REVIEW OF ANALYSIS OF MECHANISMS FOR EARLY WASTE PACKAGE AND DRIP SHIELD FAILURE

**U.S. Nuclear Regulatory Commission
Contract NRC-02-07-006**

**Center for Nuclear Waste Regulatory Analyses
San Antonio, Texas**

September 2008

Figure 2-1. Cumulative-Distribution Function for Flaw Size Before Ultrasonic Inspection in Outer Lid Weld. There Are Two Curves in the Figure: One From Bechtel SAIC Company, LLC (2004) and the Other From the Present Calculation.

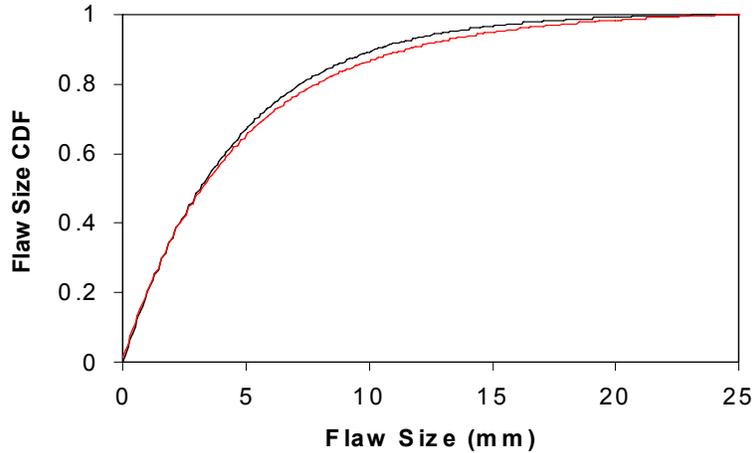
The information provided in Bechtel SAIC Company, LLC (2004, Table 7) is based on the data originally reported in Bechtel SAIC Company, LLC (2003a). These flaw sizes were obtained by an ultrasonic technique that has a best sensitivity of about 1 mm [0.039 in]. The smallest flaw size in the Y-direction reported in Bechtel SAIC Company, LLC (2003a) is 1.6 mm [0.062 in].

Thus, the resulting distribution function of flaw size is actually truncated at 1 mm [0.039 in]; the flaw-size distributions in Figure 2-1 have been extended to zero.

Figure 2-2. The Fraction of Flaws That Have an Angle Greater Than a Certain Value. The Two Curves Correspond to the Mean and 95th Percentile (Close to the Upper Bound).

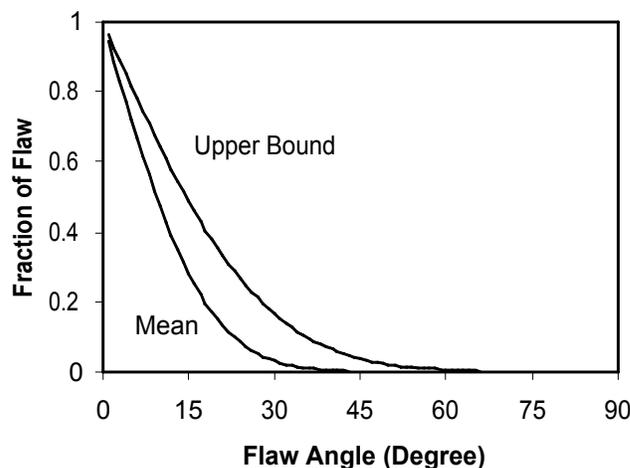
Bechtel SAIC Company, LLC (2004) reports that the fraction of flaws that have an angle, θ , greater than 45° is 0.8 percent. CNWRA found the calculation in the relevant part of

Attachment I to be correct. Additional confirmation of the calculation can be established by using the mean value of the standard deviation, σ_m , in Eqs. (2-5) and (2-6). In this case, $F_\theta \approx 1 - P_\theta(\theta, \sigma_m)$. The calculated fraction of flaws with angles, θ , greater than 45° is 0.12 percent, which is in the same order of magnitude of the reported value of 0.8 percent. Using the mean and 95th-percentile standard variation, the fraction of flaws having an angle greater than a certain value was calculated (Figure 2-2). At the 95th percentile, 3.7 percent of flaws have angles greater than 45° . Overall, CNWRA confirmed the conclusion that almost all the flaws are in the direction of the weld. Flaws that are radially oriented (i.e., making an angle of 45° or more with respect to the direction of the weld) represent less than a median value of 1 percent of the total.
